Modification of shifting shaft (turret) on 02Q gearbox.

This modification is ABSOLUTELY NECESSARY !

Original design of 02Q shifting shaft – see marked points

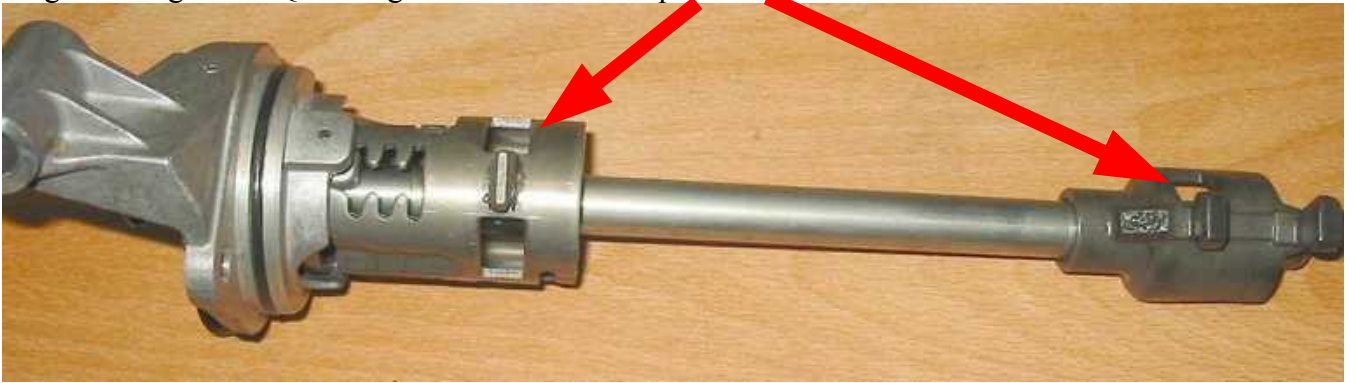
Must be made 100% for all 6° and 5° DOG-boxes !

Weld on some material:

Than grind carefully to required dimensions !
Keep also perimeter of original part !
